Vermont Yankee Nuclear Power Station

Proposed Technical Specification Change No. 263

Extended Power Uprate – Supplement No. 8

Response to Request for Additional Information

Figure EMEB-B-2-5  
VYR24-04-02 Indication Locations

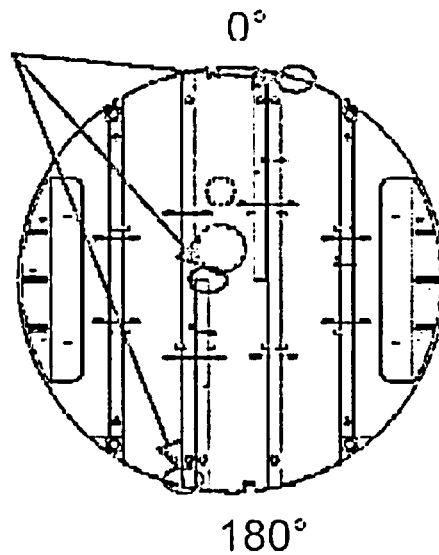
Figure EMEB-B-2-5 is a schematic of the end plate locations with respect to the overall dryer and shows a representative photograph of the indications. Table EMEB-B-2-1 summarizes the location and number of indications found on each interior end plate:

**Figure EMEB-B-2-7**  
**Cross-Section Through Banks Showing Vane Capturing Features**

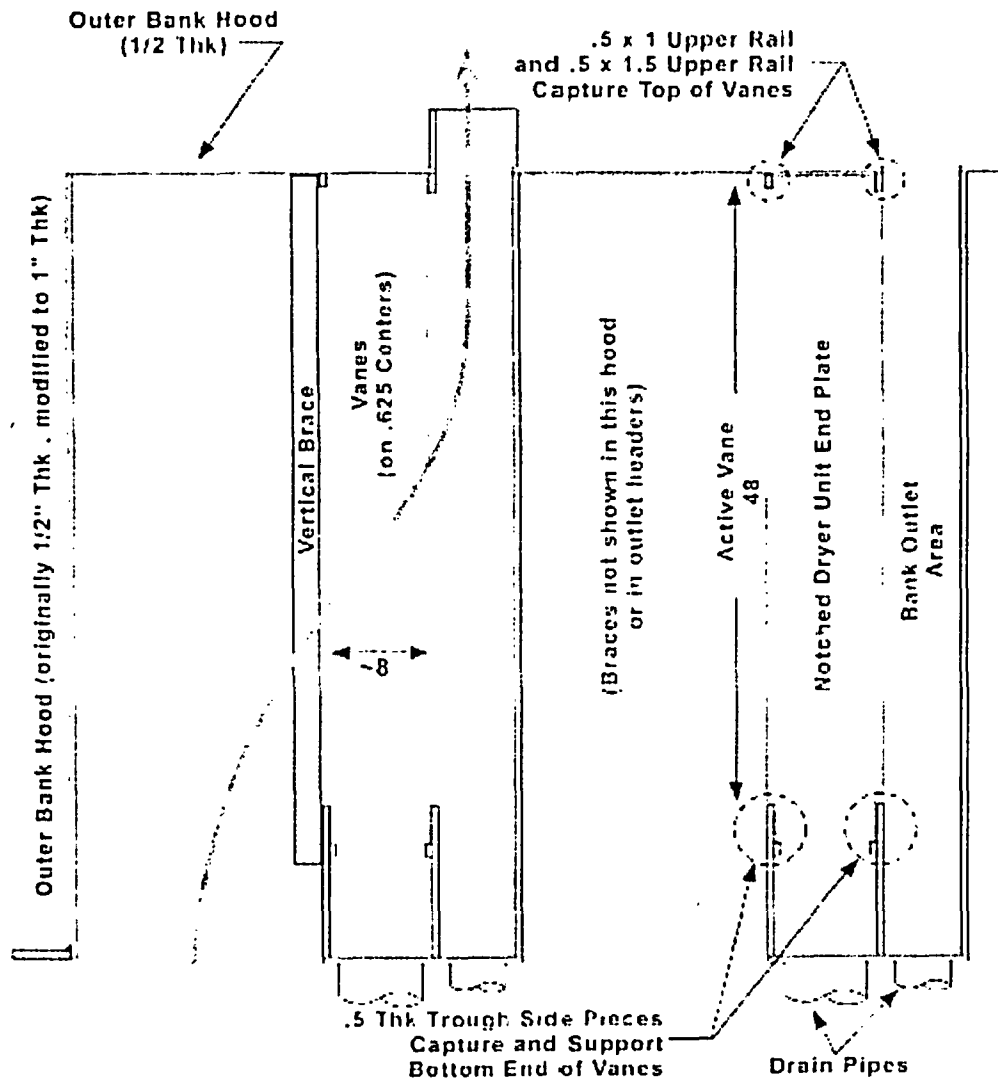
Each VYNPS steam dryer vane module assembly (dryer unit) includes two end plates. There are 16 total dryer units in the VYNPS dryer assembly. Unit end plates have a channel cross-section 8.75 inch wide with 1.25-inch high flanges and are formed from 3/16-inch thick Type 304 stainless steel. The bottom end of each unit end plate has two notches 3 inches high by ½ or 1/4-inch deep (removing most of the flanges). The upper end of each end plate has similar notches except the inlet side notch is 1-inch high and the outlet side notch is 1.5-inches high. Figure EMEB-B-2-6, taken from the vendor's dryer unit fabrication drawing shows these details. After notching, the width of the lower 3 inches of the dryer unit end plate is 8 inches. The notched lower end of the dryer unit end plate is fit between the vertical sides of the lower trough of the dryer bank (an 8-inch wide space). Similarly, the notched upper end of the dryer unit end plate fits between ½-inch thick vertical rail pieces as shown in Figure EMEB-B-2-7.

members and plates at the end of each trough. The upper rail pieces, as shown in Figure EMEB-B-2-7, capture the upper end of the dryer units. Tie rods, nuts and spacers control spacing of the dryer vanes themselves as shown in Figure EMEB-B-2-6.

Figure EMEB-B-2-8  
Connection of Unit End Plate with Dryer Assembly

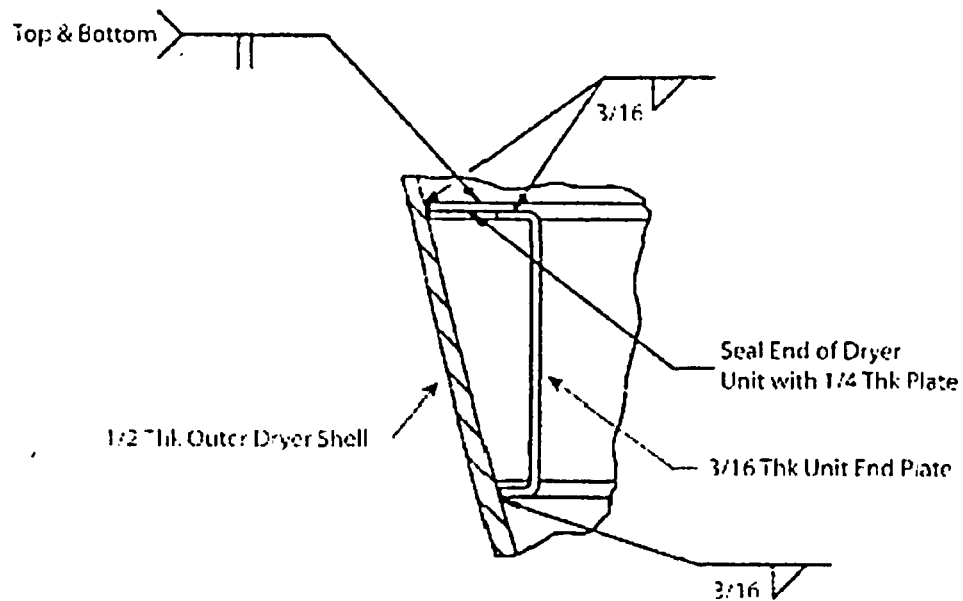
Each dryer bank includes three or four dryer units that are installed into the bank trough. 3/16-inch vertical fillet welds are used to join the end plates of adjacent dryer units. Bank C is split into two halves with opposite steam flow directions. At both ends of the bank, the last dryer unit end plate is welded to the ½-inch thick cylindrical shell plate with a 3/16-inch fillet weld. On the outlet side, a ¼-inch thick closing piece is used between the unit end plate and the ½-inch vertical shell plate (see Figure EMEB-B-2-8 for typical details).

Figure EMEB-B-2-9  
Cut-away of Bank Showing Unit End Plate

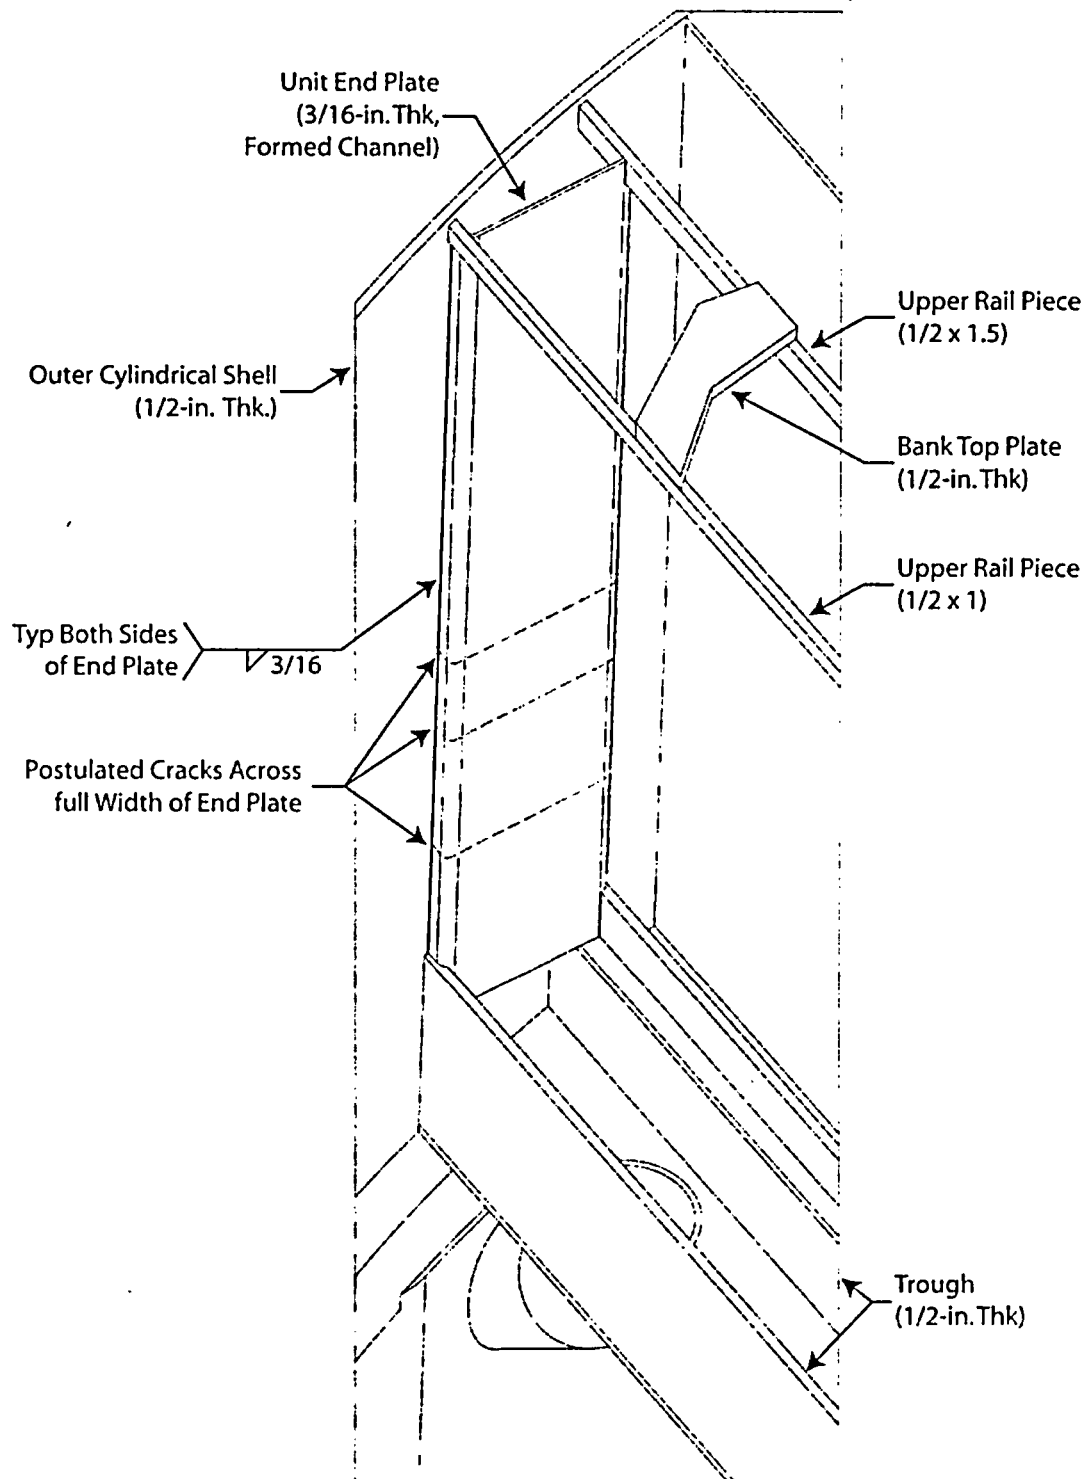
A worst-case scenario would postulate that the indications could propagate from the inlet side flange across entire end plate including the outlet side flange. This is very unlikely, but it would not result in any significant structural or performance impact to the steam dryer. For the purpose of this discussion it is postulated that the end plate horizontal indications propagate across the entire 8.75-inch unit end plate width including both the inlet and outlet side flange, as shown in Figure EMEB-B-2-9. Such full width through thickness cracks would have no structural impact nor is there any concern for loose parts. The separated end plate sections, as shown in Figure EMEB-B-2-9, are still attached and will continue to function.

Figure EMEB-B-2-10  
VYNPS Dryer Indications Schematic

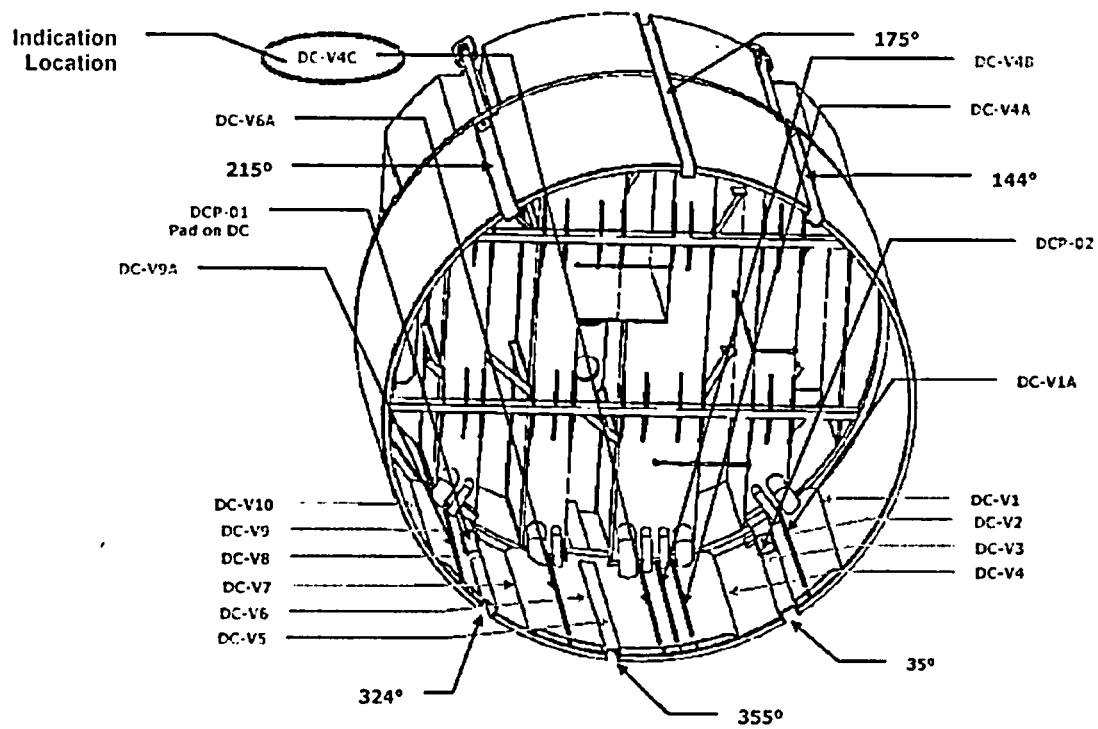
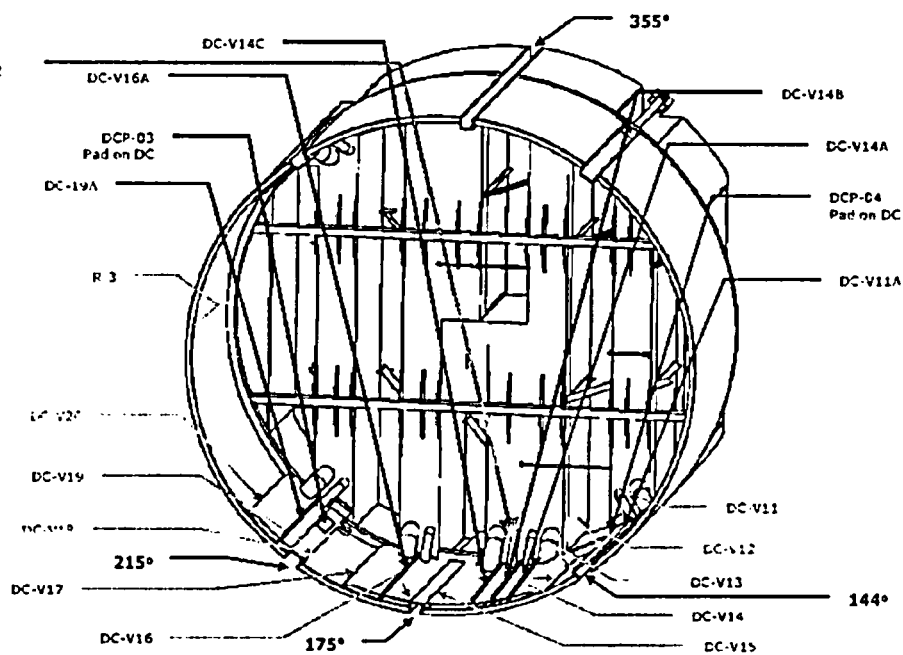
During the internal inspection in the Drain Channel DC-V04C weld, an indication was noted starting near the top of the weld and continuing down approximately 12.0 inches. Additionally, an indication in the drain channel adjacent to the drain pipe at 185 degree azimuth was noted. Figure EMEB-B-2-10 is a schematic of the indication locations with respect to the overall dryer. Figures EMEB-B-2-11 and 12 are photographs of the indications from the inspections.

Figure EMEB-B-2-12  
Inspection Indications – Drain Channel

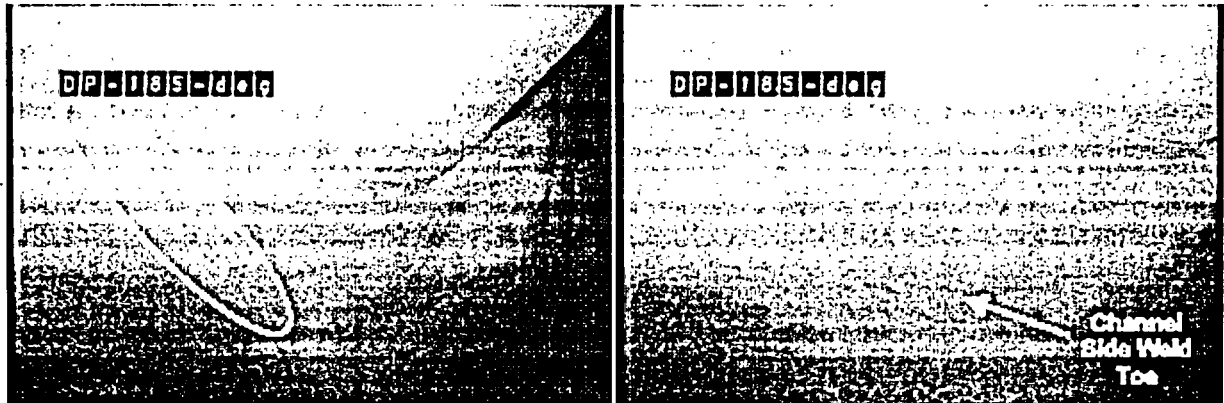
This weld appears to be ground flush and is very difficult to see the weld toe. But the indication appears to be at the drain channel weld toe 1-AZ area and not in the weld material.

Figure EMEB-B-2-13  
VYNPS Drain Channel Indications Schematic

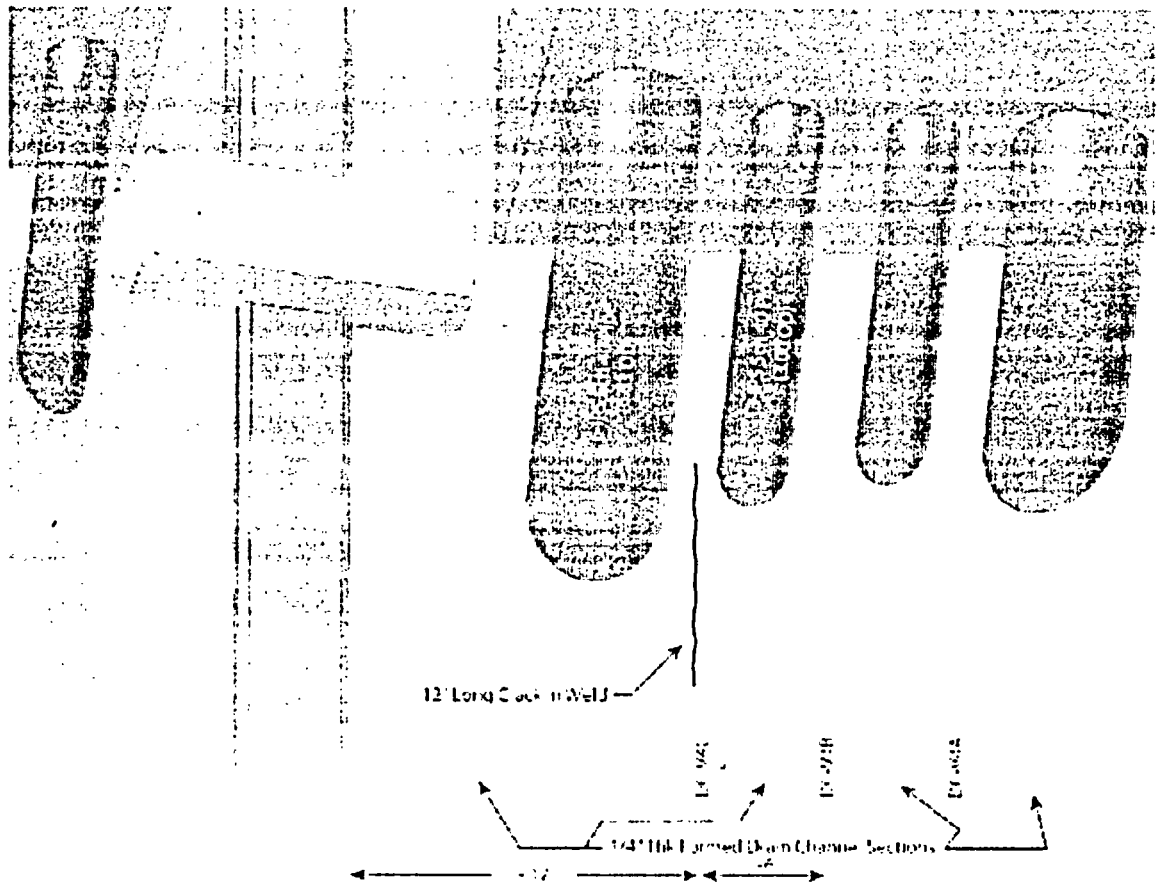
The second indication discussed in inspection report VYR24-04-04 is located to the left side of the 91.5-inch long vertical drain channel (DC-4VC) weld as shown in Figure EMEB-B-2-13. A cross section through this drain channel with a detail for weld DC-4VC is shown as Figure EMEB-B-2-14. Because weld DC-4VC is one of several final field assembly welds, it is possible that this was an area of less than optimum fit up. The length of this indication is estimated at approximately 12 inches or 13% of the weld length. Careful examination with the Remotely Operated Vehicle was able to show that the indication is located in weld HAZ base material and not the weld itself. There is visual evidence of heavy grinding in the area of the indication. Based on the HAZ location and the somewhat jagged appearance this indication is most likely IGSCC.

VYNPS Overpressure Credit for NPSH DBA LOCA-Long Term

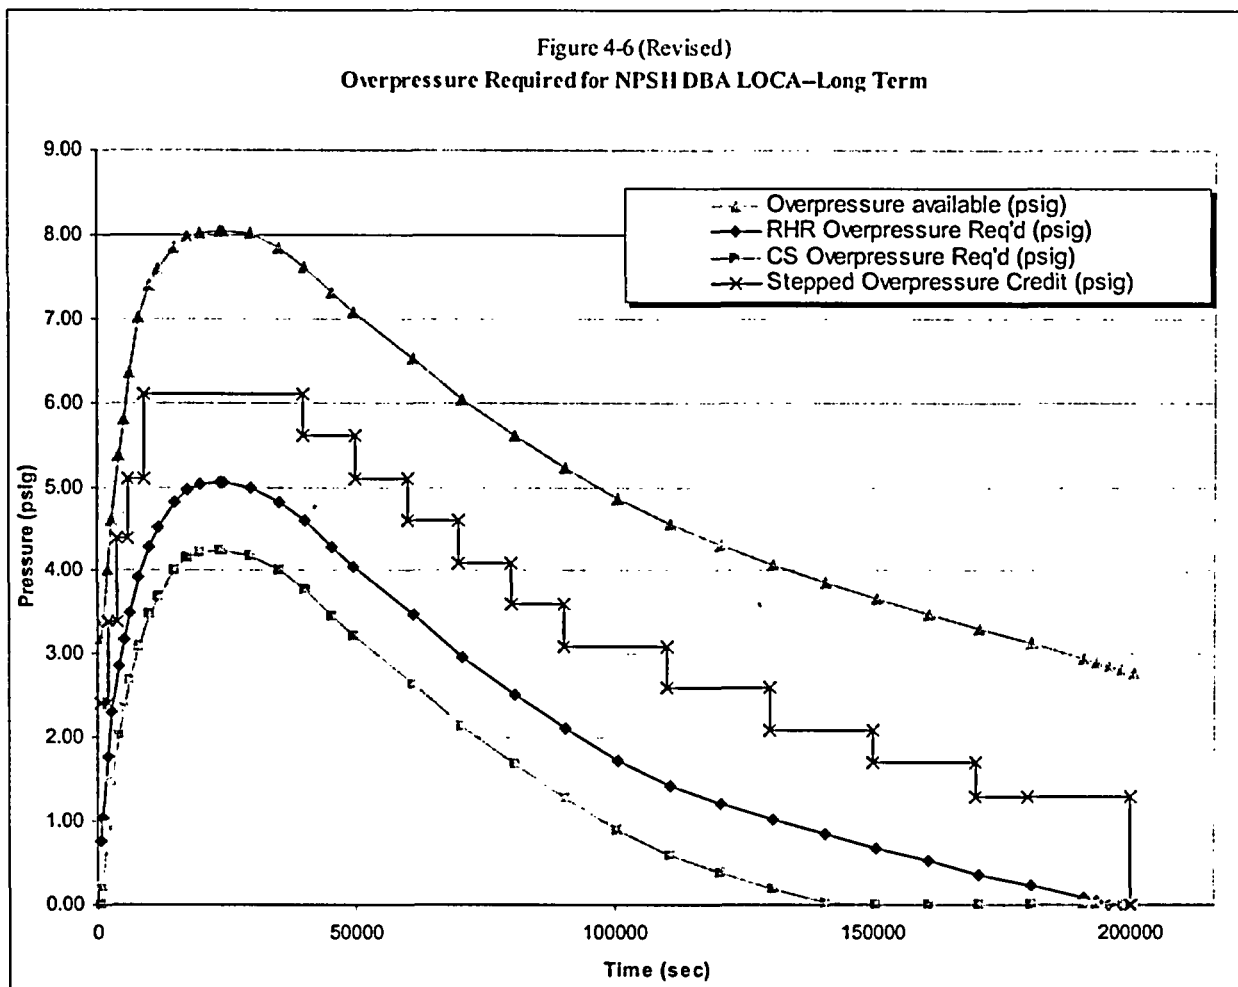
The application dated September 10, 2003 (Reference 1), Attachment 6, Table 4-2 and Figure 4-6, show that the containment accident pressure requested for adequate available NPSH is 1.3 psig at 50 hours. When is containment accident pressure no longer required?

Revised Table 4-2 and Figure 4-6 are enclosed. The overpressure credit requested has not changed. The time after LOCA has been extended from 180,000 seconds to 200,000 seconds.
